REGULAR PLANNING COMMISSION AGENDA

1. **SMF2023 0003:** Shared Access Subdivision: Final approval for shared access subdivision of Tract B into four (4) lots. Access via Wee Burn. -**APPROVED WITH CONDITIONS AS AMENDED**

PLANNING COMMISSION STAFF REPORT
MAJOR SUBDIVISION SMF2023 0003
HEARING DATE: AUGUST 22, 2023

DATE: August 11, 2023
TO: Michael LeVine, Chair, Planning Commission
BY: David Matthew Peterson, Planner II
THROUGH: Jill Maclean, Director, AICP

BLACKTAIL MOUNTAIN ESTATES B
TRACT B, BLACKTAIL MOUNTAIN ESTATES, PLAT 2021-32
A FRACTION OF US SURVEY 471
WITHIN THE CITY AND BOROUGH OF JUNEAU, ALASKA

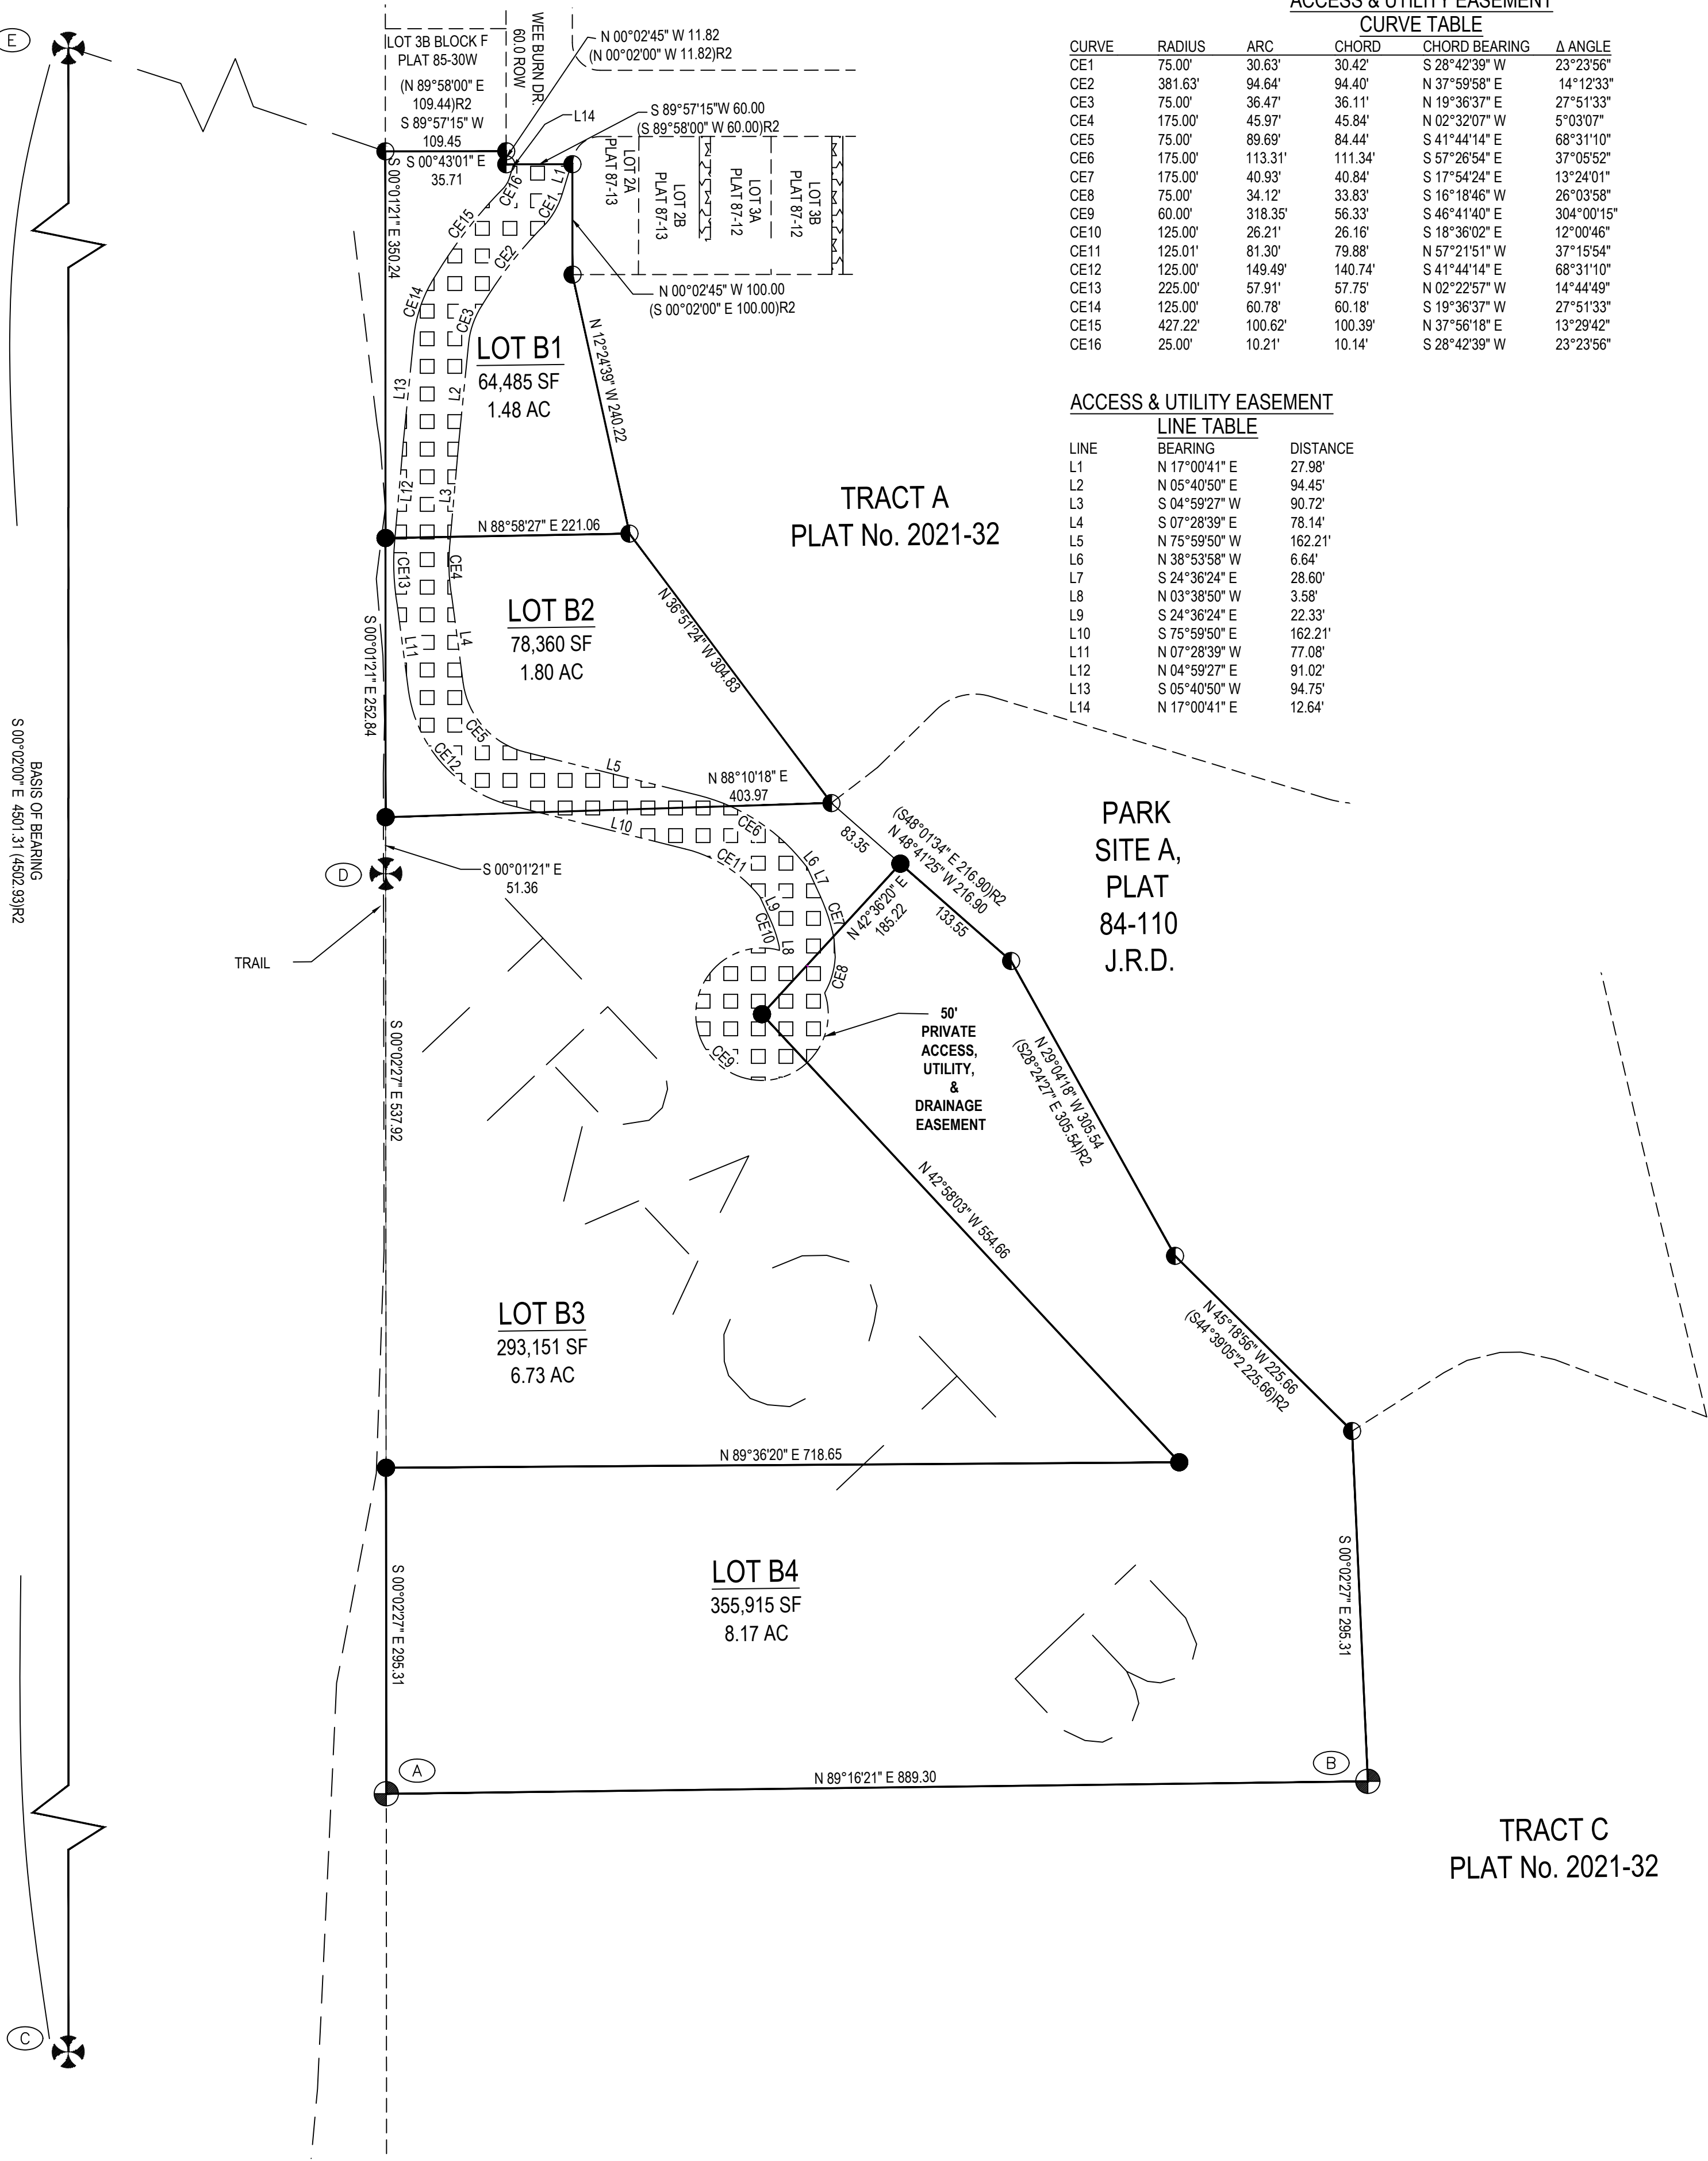
1. Tract B
 - a. Sheet 1
 - i. Remove Basis of Bearing detail and show monuments on line with line breaks, it is unclear as it is currently shown.
 - ii. Place "Tract B" in dashed text across the original tract.
 - iii. Describe "Tract A" and "Tract C" on plat body with "Plat No 2021-32 JRD".
 - iv. Rephrase Park Site A to read, "PARK SITE A, PLAT No. 84-110 JRD".
 - v. Show street names in vicinity sketch.
 - vi. Add "drainage" to access and utility easement.
 - vii. East boundary of Lot B4 needs bearing and distance.
 - viii. Add driveway easement linetype and hatch.
 - ix. Remove 10' access easement from legend.

- i. In basis of bearing statement, change Chilkat Monuments to GLO monuments.
- ii. Change all signatory dates to 2022.
- iii. Remove set primary monument detail.
- iv. Monument details C and D should read Pipe instead of Pine.
- v. Change plat name in title block to match Sheet 1 as shown above.
- vi. Can remove legend and scale bar this sheet.
- vii. Use this access note for private shared access subdivisions (CBJ49.35 DIVISION 2) (i.e. access to 1 or more lots is via an easement and some lots have no right of way frontage)

PLAT OF
BLACKTAIL MOUNTAIN ESTATES B
A SUBDIVISION OF
TRACT B, BLACKTAIL MOUNTAIN ESTATES, PLAT 2021-32
A FRACTION OF US SURVEY 471
WITHIN THE CITY AND BOROUGH OF JUNEAU, ALASKA
JUNEAU RECORDING DISTRICT

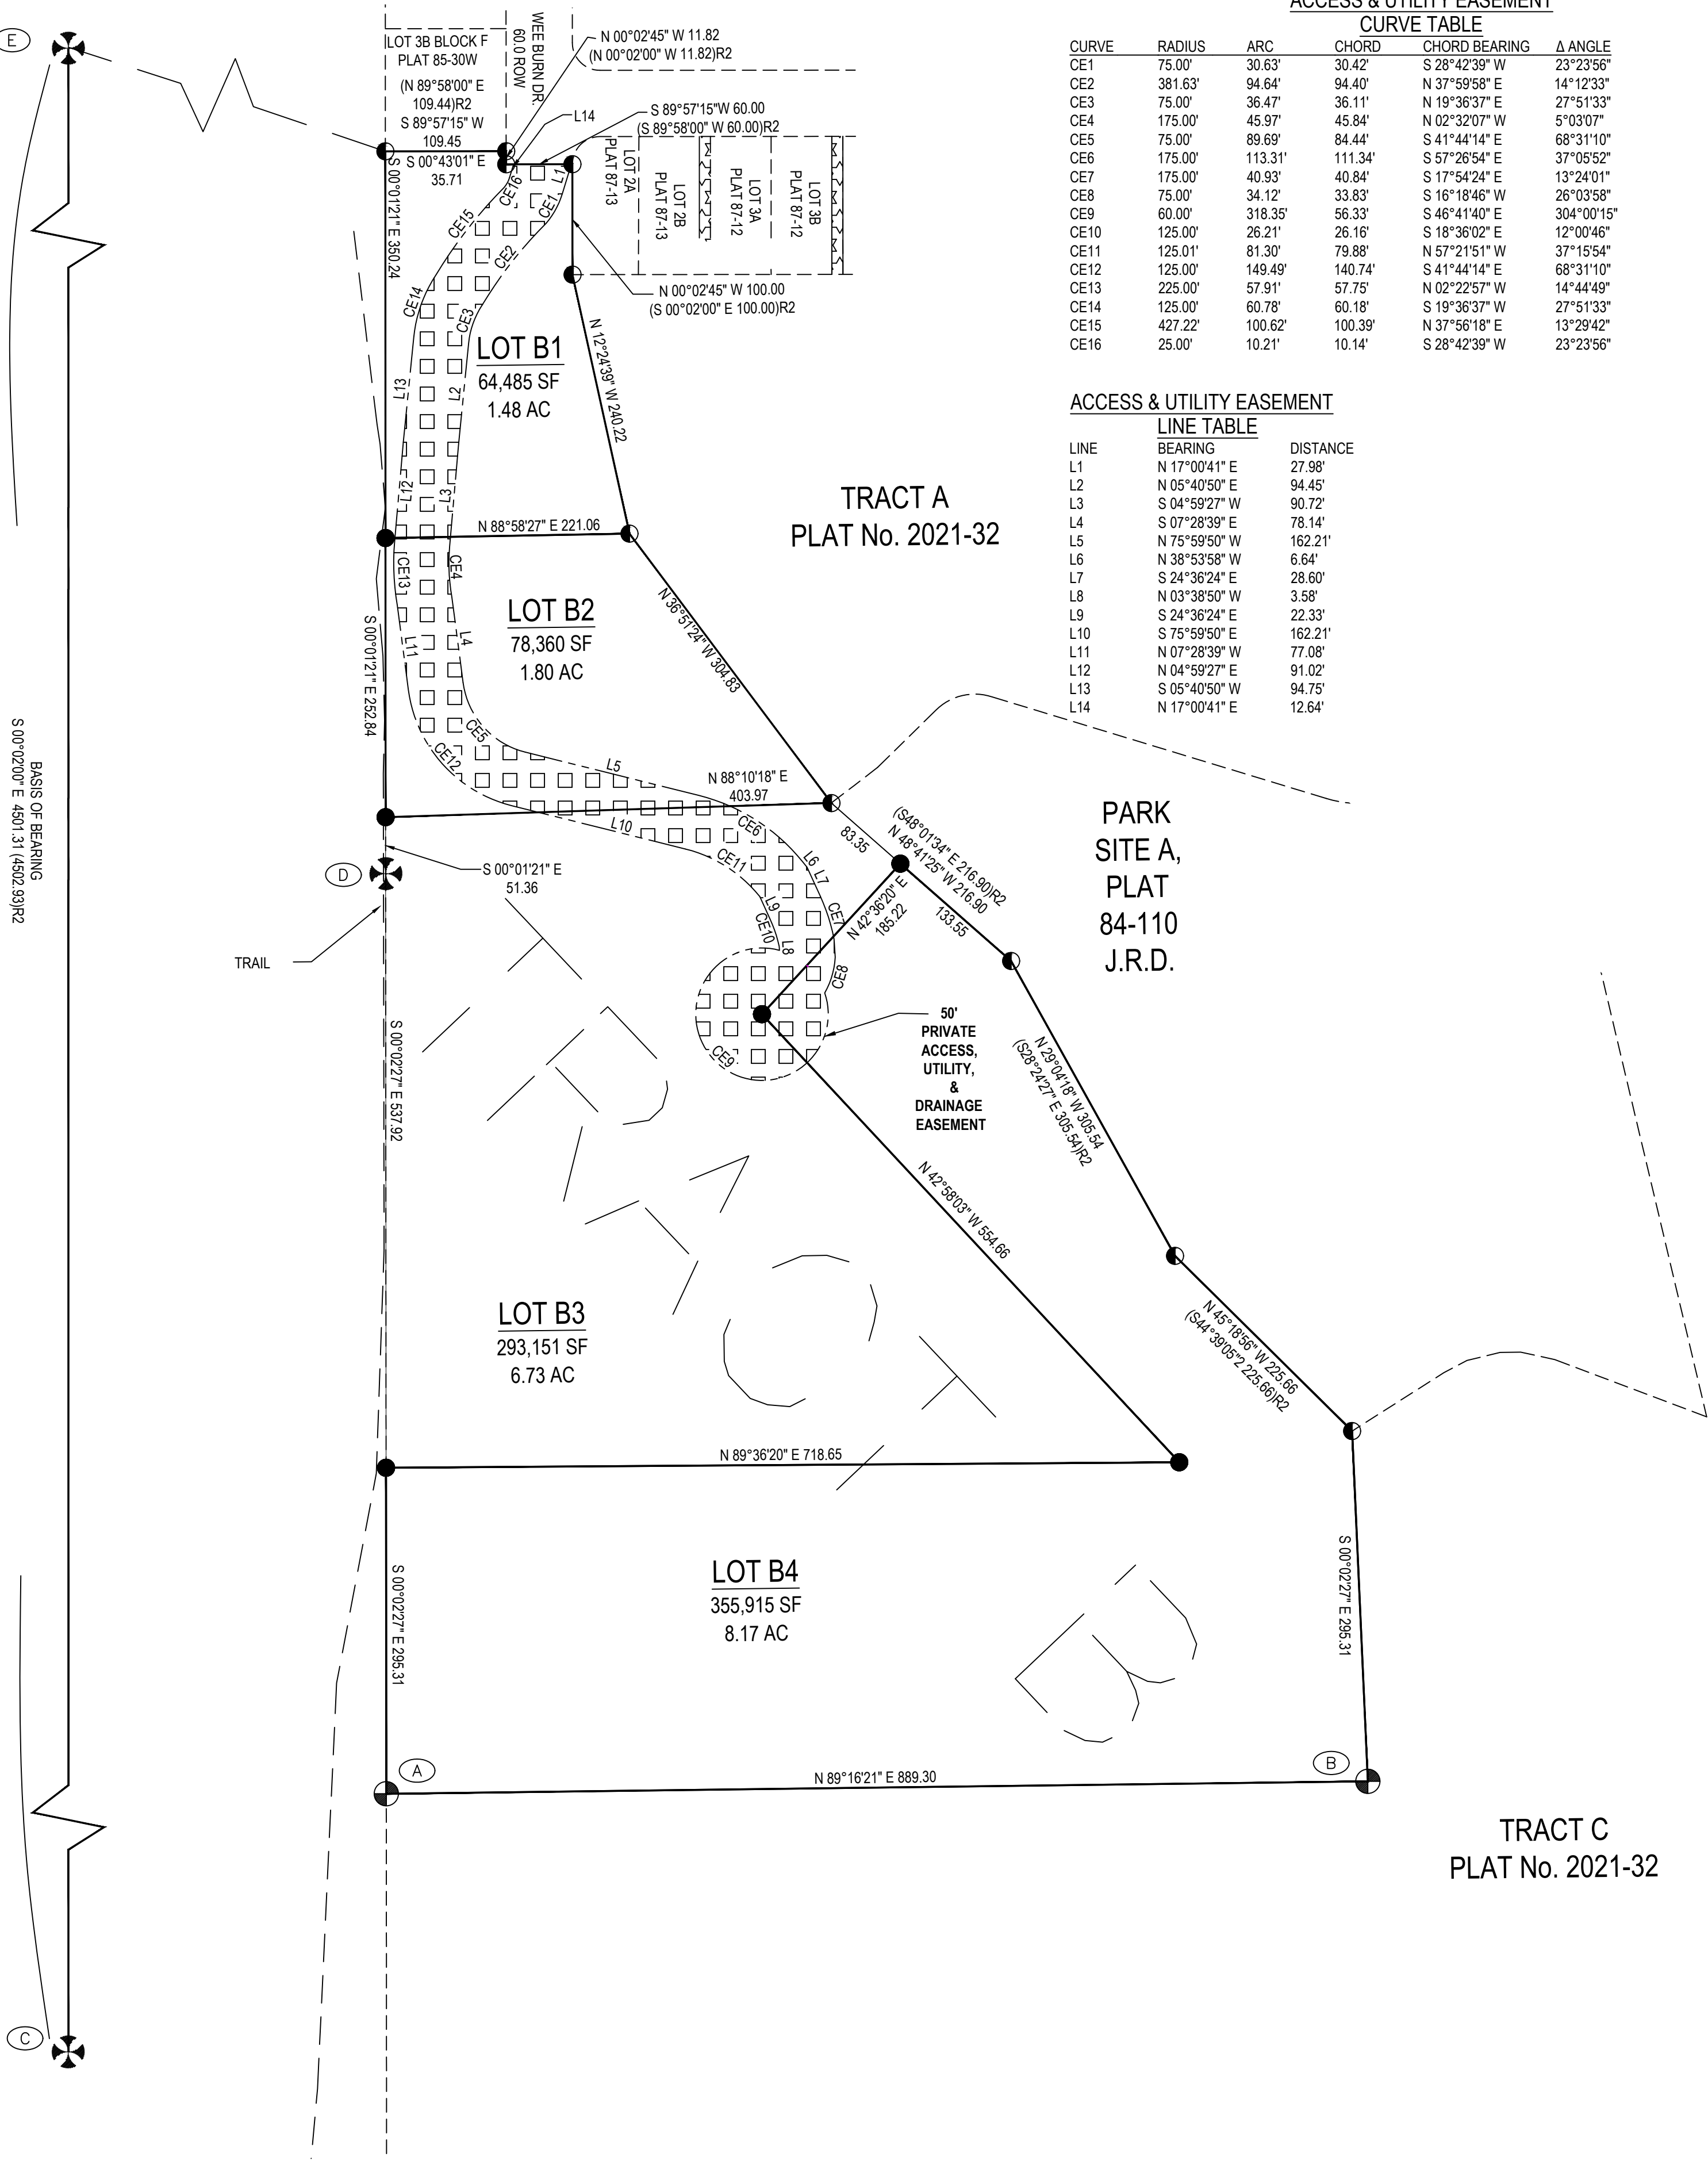
Condition: Plat Note 9 must be updated to include, "...RECORDED WITH THIS SUBDIVISION," before the Chair of the Planning Commission signs the Final Plat.

Finding: No. Prior to the Planning Commission Chairman signature, note 9 on page 2 will need to be a condition of Final Plat recording.
